# Rezoning Transportation Analysis

Petition Number: #2022-037

Date	Description
07-28-22	First Review (KP)
08-23-22	Second Review (WB)
09-22-22	Third Review (KP)

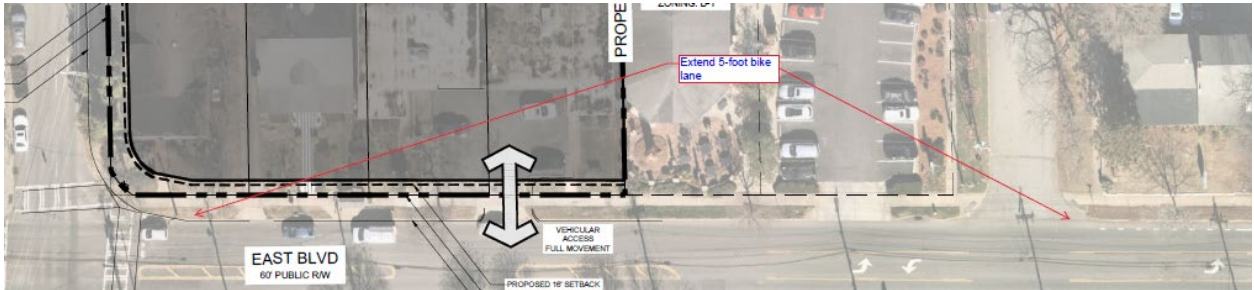
- a. **East Boulevard:** Revise site plan and conditional note(s) to commit to dedicate 42-feet of right-of-way from the road centerline.

- b. **Scott Avenue:** Revise site plan and conditional note(s) to commit to dedicate 35.5-feet of right-of-way from the road centerline.

The site plan shall label and dimension the right-of-way from the road centerline.

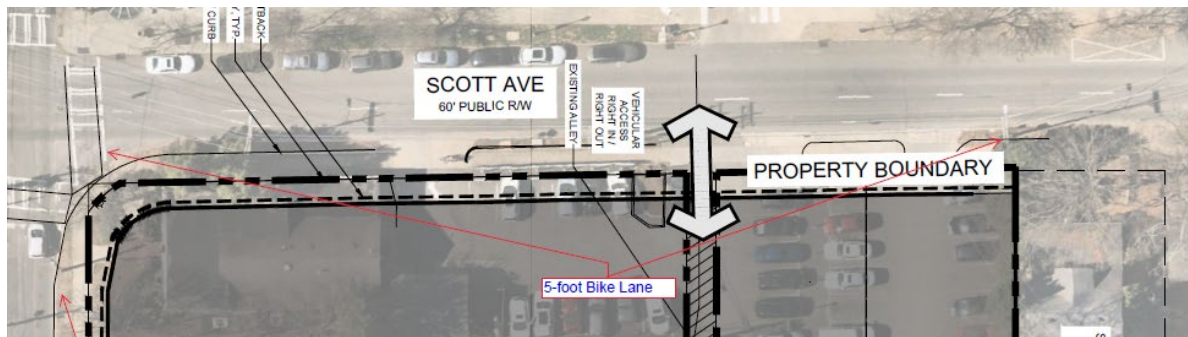
- 6. **Outstanding Comment from 08-23-2022:** Revise site plan and conditional note(s) to commit to widen Scott Avenue and provide a 5-foot bike lane across the site's frontage.  
**Note added (8/23/22)** The petitioner has requested to restripe the existing travelway to match the Scott Avenue typical section south of East Blvd (5-ft bike lane without a buffer) if the existing travelway can geometrically accommodate the existing on-street parking, 2-thru lanes and a 5' bike lane. Comment to remain until addressed or until CDOT evaluates and approves request.
